CNL-16-093

Browns Ferry Nuclear Plant, Units 1, 2, and 3
Renewed Facility Operating License Nos. DPR-33, DPR-52, and DPR-68
NRC Docket Nos. 50-259, 50-260, and 50-296

Subject: **Proposed Technical Specifications (TS) Change TS-505 - Request for License Amendments - Extended Power Uprate (EPU) - Supplement 19, Responses to Requests for Additional Information**

**Responses to NRC Electrical Engineering Branch Requests for Additional Information EEEB-
RAIs 5 through 25**

Figure EEEB-RAI 7-1

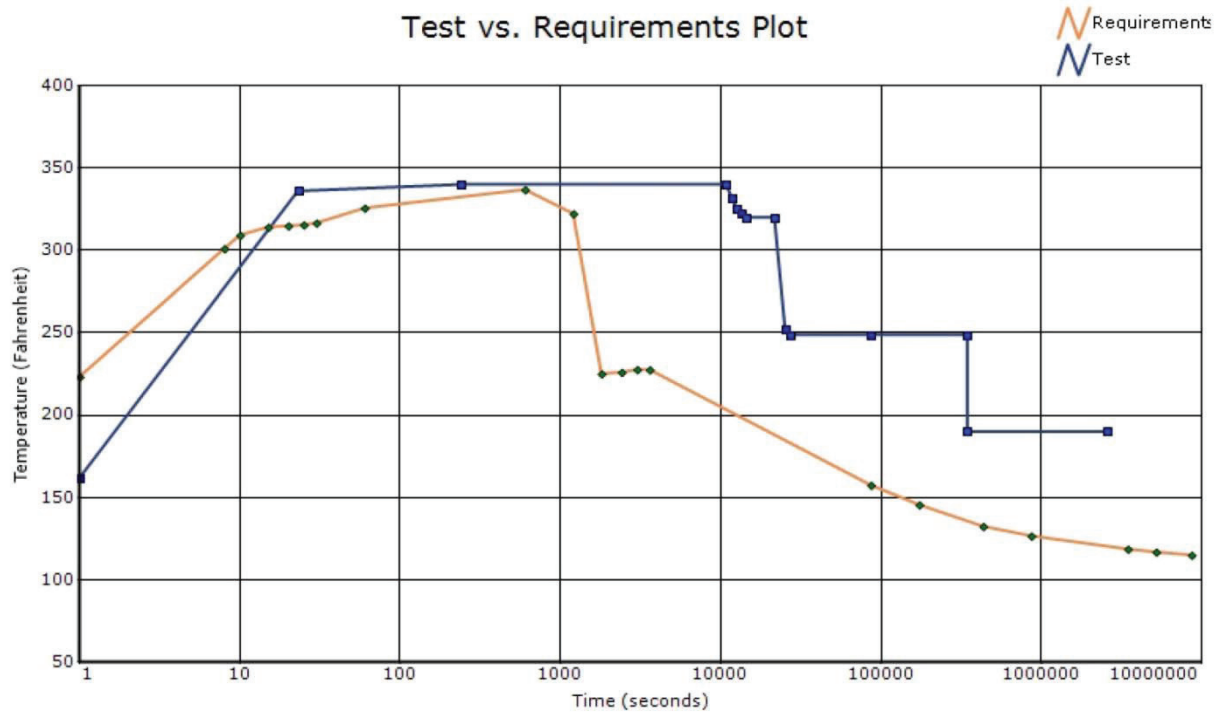
Provide the current component qualification temperature profile of EQ electrical equipment (considering the qualified temperature of worst case components) inside primary containment to confirm that it bounds the EPU drywell temperature profile shown in Figure 2.3-1. Also, discuss how the temperature margins in the Institute for Electrical and Electronics Engineers Standard 323-1974 will be maintained under EPU conditions.

Although Figure 2.3-1 of Attachment 7 of the BFN LAR shows that the EPU drywell profile exceeds the CLTP drywell profile, the individual component qualification temperature testing still bounds the EPU drywell temperature profile. Note 1 of Table 2.3-1 states that "Current component qualification testing bounds the temperature increase." This statement is based on the result of accident degradation equivalency (ADE) calculations which support that the current component qualification testing exceeds the EPU drywell temperature profile. This is an industry accepted method of comparing the test and plant accident temperature profiles to demonstrate acceptable post-accident qualification.

Figure EEEB-RAI 18-1 (This figure is applicable to all Unit 1, 2, and 3 4KV Unit Boards)

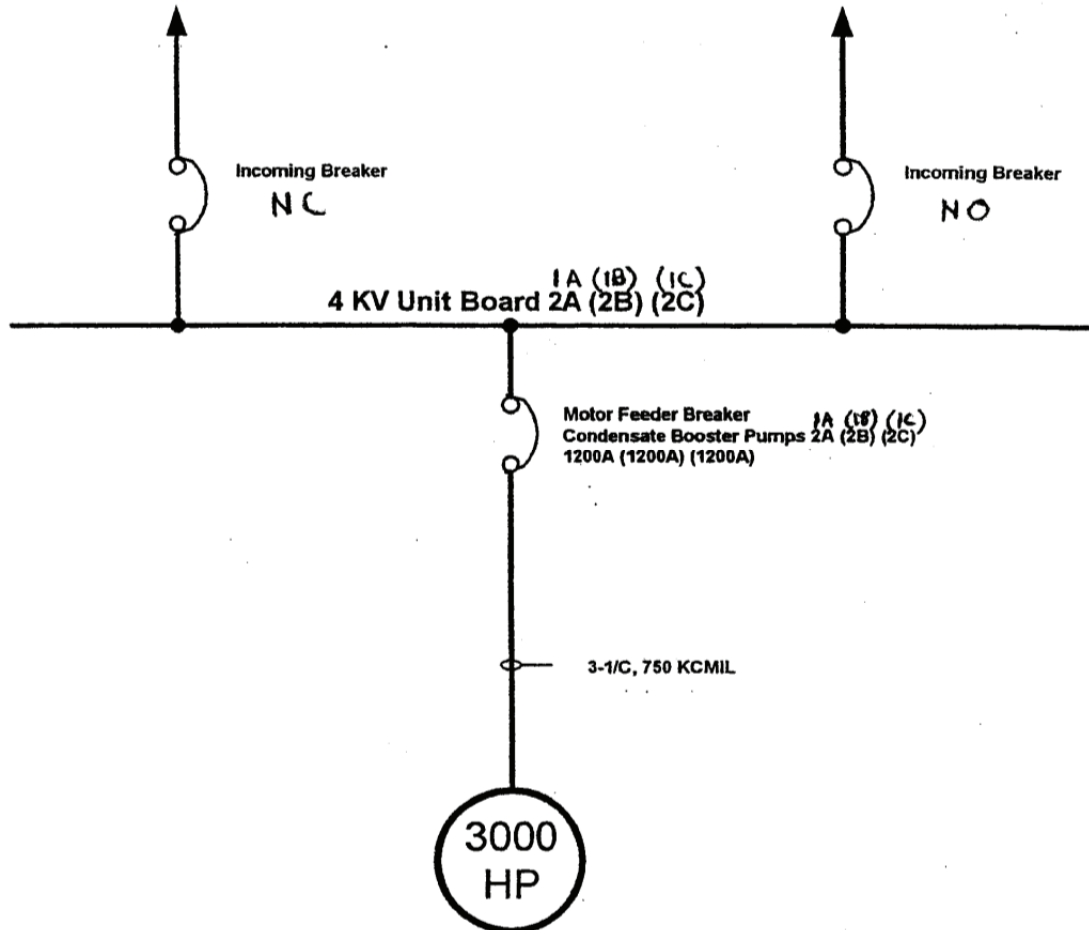
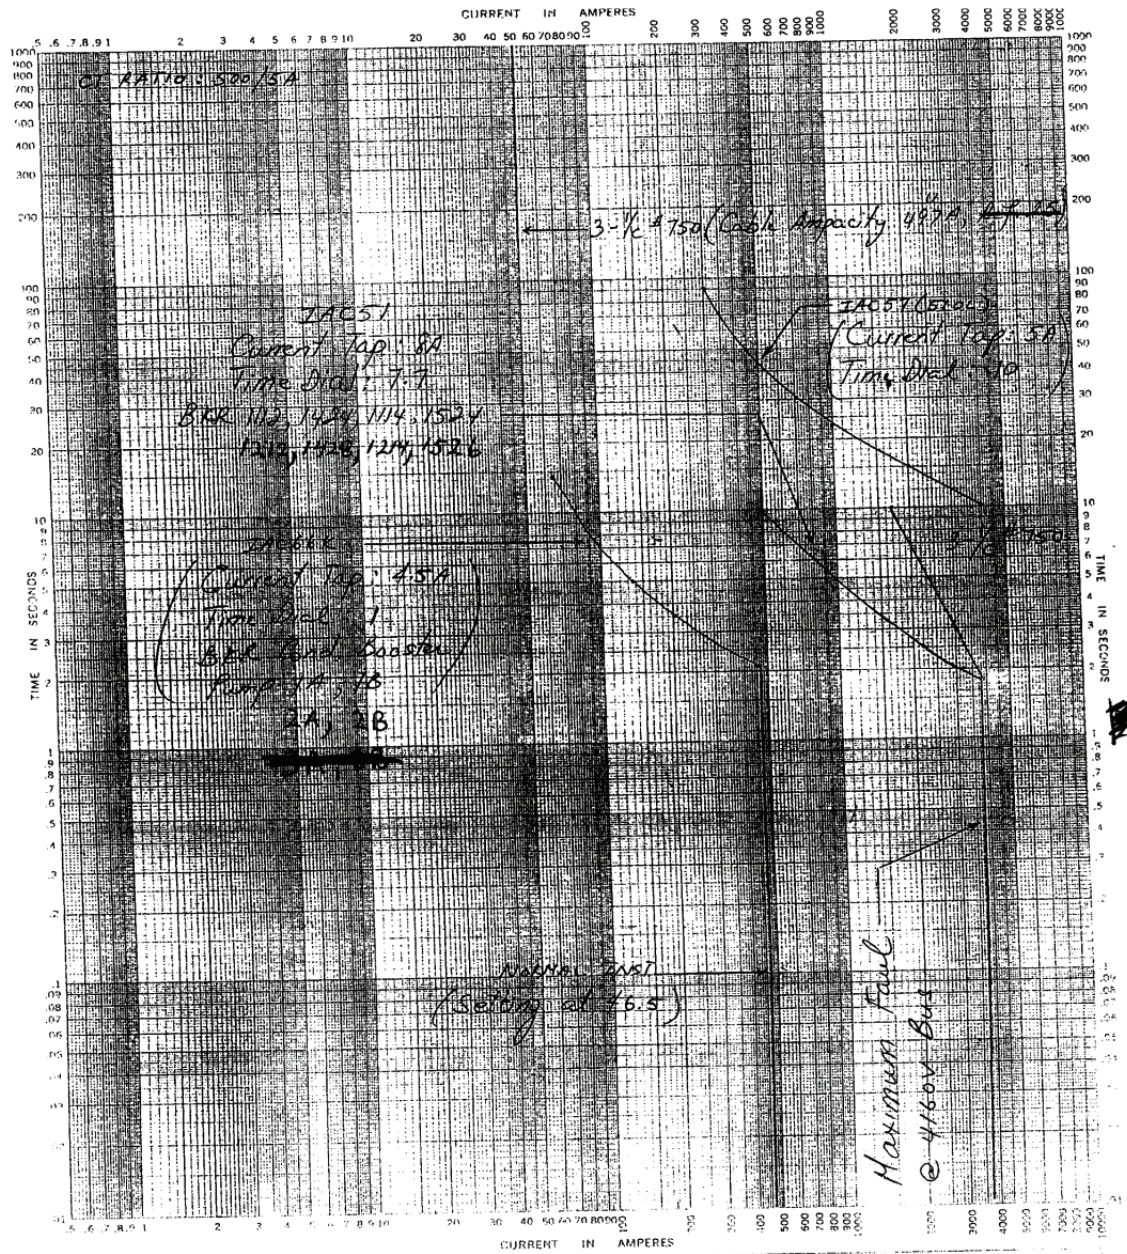
- a. Identify the balance of plant buses/boards that power the CPs and CBPs, and provide the worst case loading of these buses/boards and margin available at CLTP and EPU conditions. Also, provide a copy of all the Single Line Diagrams listed on page E5-5 provided in response to EEEB-RAI-2.*
- b. Provide a summary of relay settings to show that CBPs and their associated boards remain adequately protected during transient loading. Also, provide a duration of the transient loading.*

Figure EEEB-RAI 18-1 provides a schematic of the normal and alternate board feeds and the CBP motor feed.
